Subject: Tilbuster 2 Solar Farm EIS (SSD-69799460)

CPHR Assessment Summary for Tilbuster 2 Solar Farm Environmental Impact Statement (SSD-69799460)

ATTACHMENT C Detailed comments for Tilbuster 2 Solar Farm Environmental Impact Statement (SSD-69799460)

Figure 1: The proposed temporary construction compound (left image - orange hatching) has not been included in the BDAR development footprint (right image – white polygon).

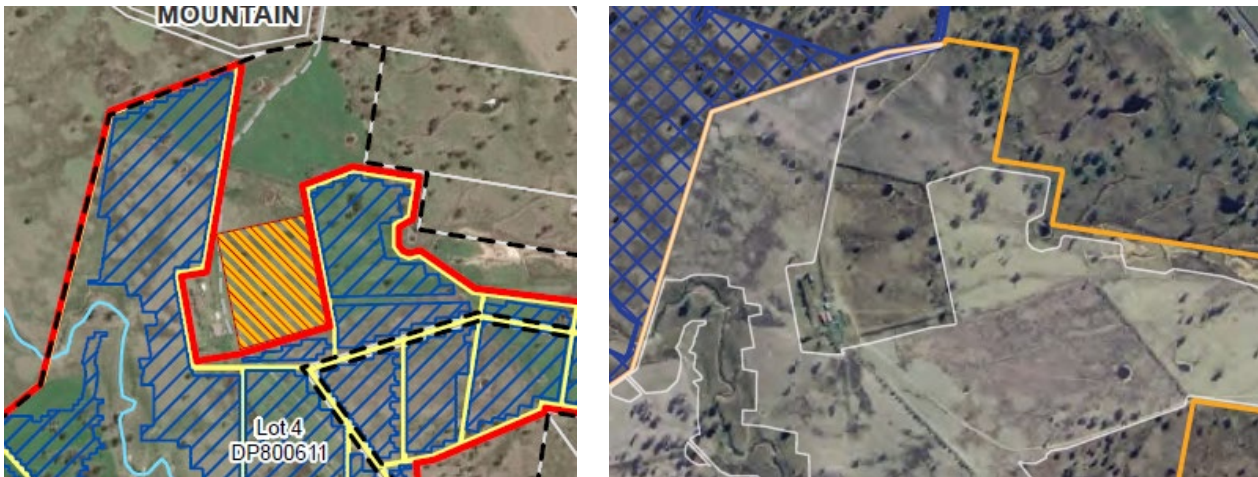
In section 1.3.2 of the BDAR the assessor has described the development footprint as the land directly impacted by the proposal, including the solar array, perimeter fence, access roads, transmission line footprint and known temporary construction areas. The assessor then states in section 1.3.4 of the BDAR that a temporary construction compound and laydown area would be located outside the development footprint but within the development site.

The proposed temporary construction compound and laydown area identified in Figure E.1 of the EIS represents a known temporary construction area, which must be included in the development footprint assessed in the BDAR (refer to Figure 1 below).

2. The BDAR description of the proposed development footprint be reviewed and revised to clearly demonstrate that all components of the development have been considered in accordance with section 2(3) of the BAM and the remaining sections of the BDAR and the BAM-C amended as required.

Figure 2: Sections of proposed security fencing not included in the development footprint assessed in the BDAR (broken red lines within the red polygons).

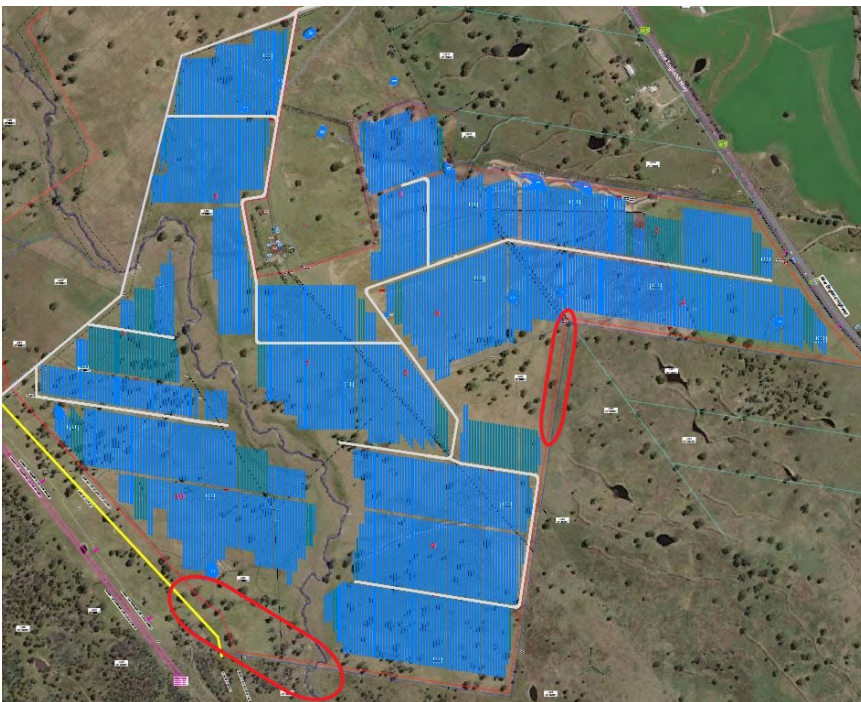
The proposed development footprint shown in Figure 1 of the BDAR does not include all sections of the proposed perimeter fence illustrated in the master plan contained in Appendix 2 of the BDAR (refer to Figure 2 below). The perimeter fence will result in direct impact for construction and long-term indirect impact on retained ecological communities within the fenced area by restricting access to some fauna species required for propagule exchange and maintenance of vegetation structure (e.g. macropods).

Figure 6: The main areas of native vegetation (in red polygons) retained within the development site, which would be isolated by the location of proposed perimeter fencing.

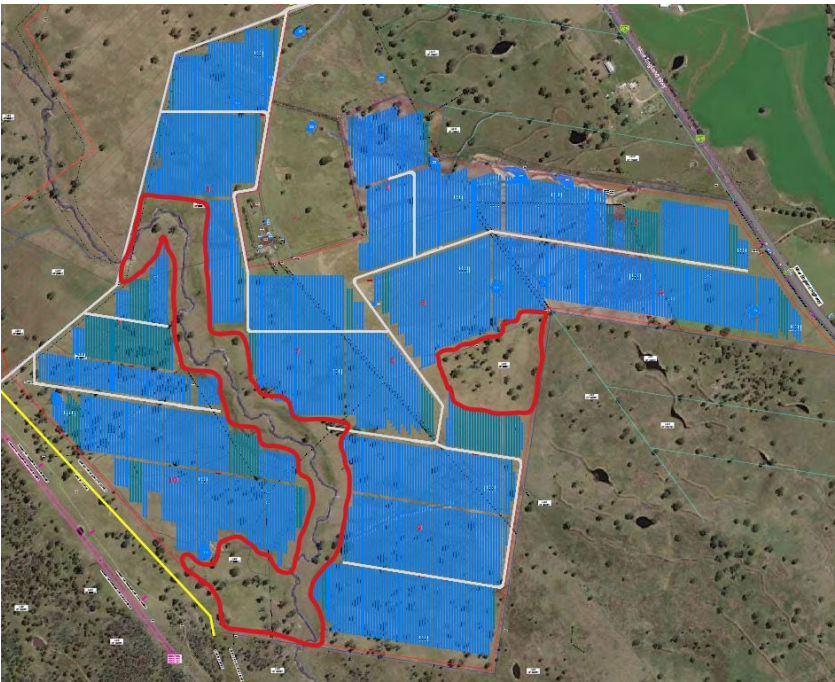
In section 5.1.4 of the BDAR, the assessor has indicated north-south habitat connectivity would be maintained by providing a movement corridor along the Duval Creek riparian zone. However, the assessor has not considered the potential barrier effects of proposed perimeter fencing on fauna access to the riparian zone and other native vegetation remnants to be retained on the development site.

If habitat connectivity is not considered in the design and location of perimeter fencing, then long-term indirect impacts may arise on the floristic composition and structure of remnant vegetation retained within the development site (refer to Figure 6 below) by the fencing restricting access for

some fauna species that exchange propagules and maintain vegetation structure (e.g. macropods).

10. Proposed perimeter fencing be placed as close as possible to the solar arrays and internal roads to minimise isolation of retained native vegetation and optimise potential for fauna movement along the Duval Creek riparian zone.

Figure 7: Indicative re-alignment of perimeter fencing (green lines) closer to the solar arrays and internal roads to minimise isolation of retained remnants of native vegetation.

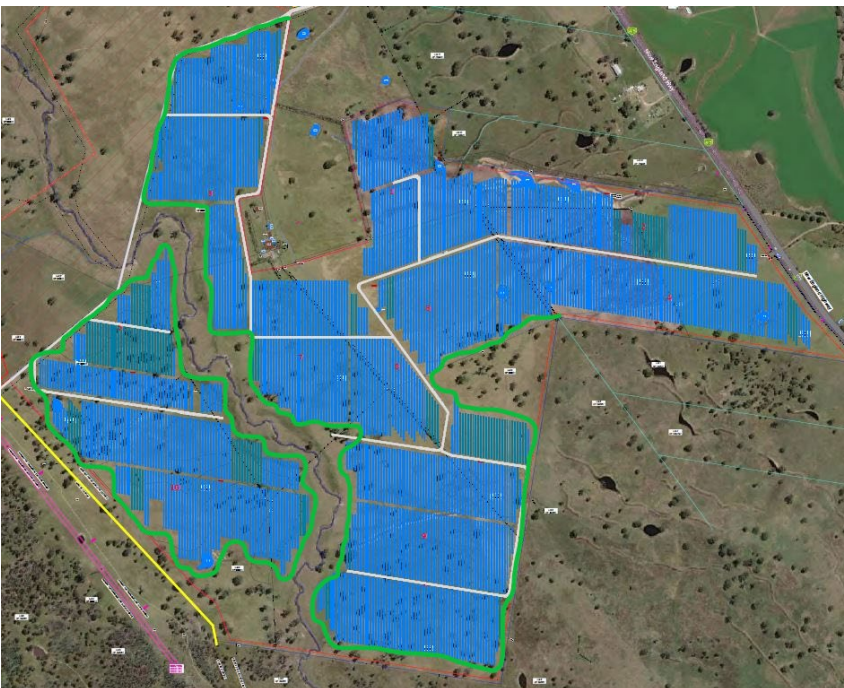
These indirect impacts of perimeter fencing can be reduced by realigning the fence as close to the solar arrays and internal roads as possible to minimise isolation of retained native vegetation and maintain fauna movement along the Duval Creek riparian zone (refer to Figure 7 below).
